Z-51
(2016)

PETITION NO: Z-51

ZONING COMMENTS:

STAFF RECOMMENDATIONS

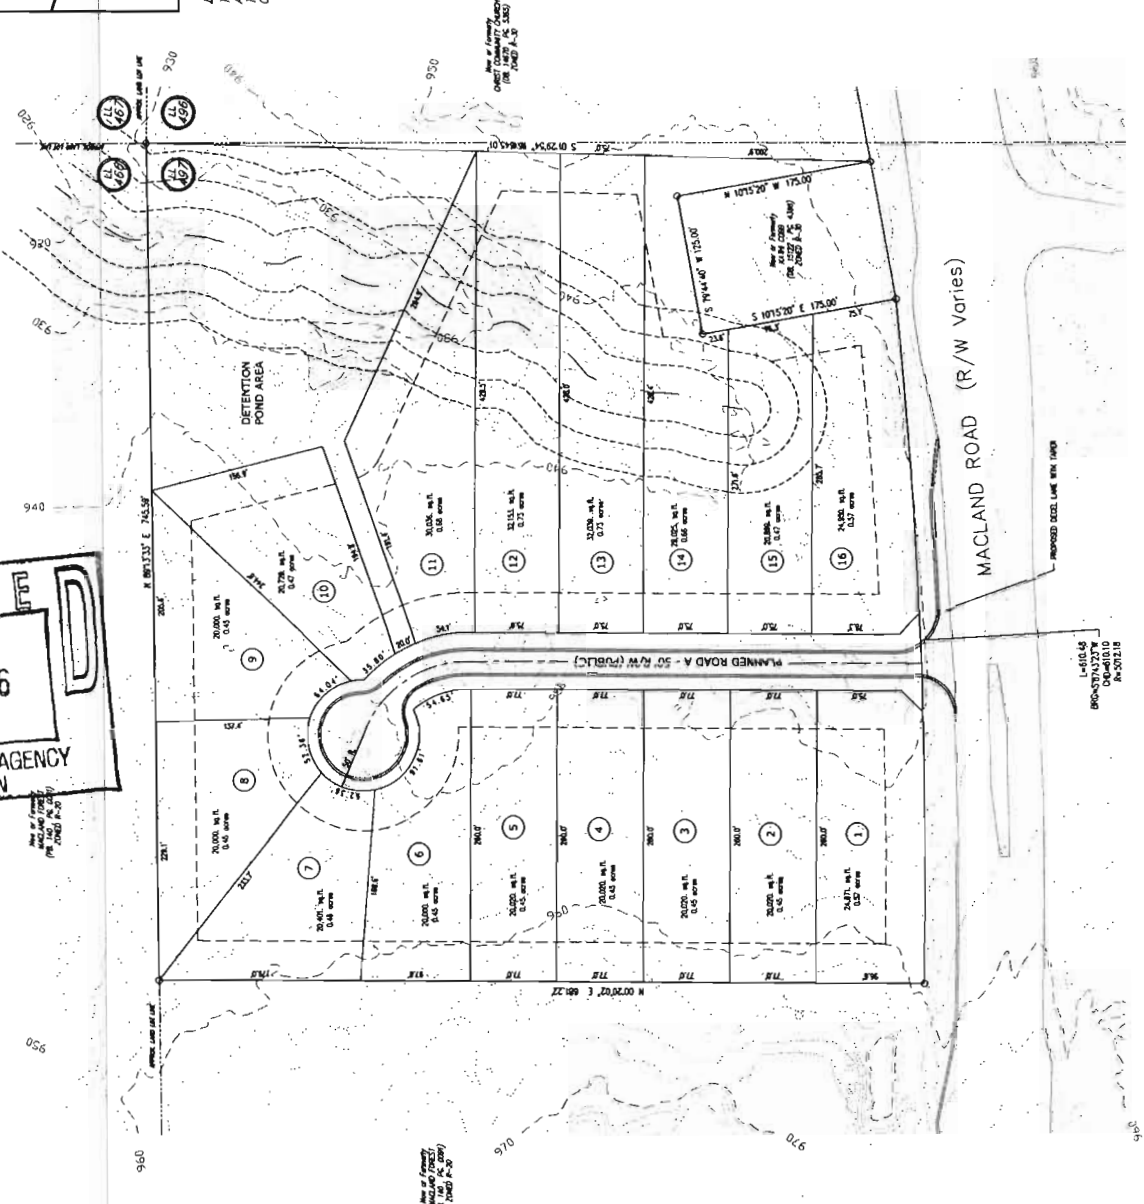
- No Stormwater controls shown _____
- Copy of survey is not current – Additional comments may be forthcoming when current site conditions are exposed.
- No site improvements showing on exhibit.

1. Site plan received by the Zoning Division on April 7, 2016, with the District Commissioner approving minor modifications;
2. Water and Sewer Division comments and recommendations;
3. Stormwater Management Division comments and recommendations; and
4. Department of Transportation comments and recommendations.
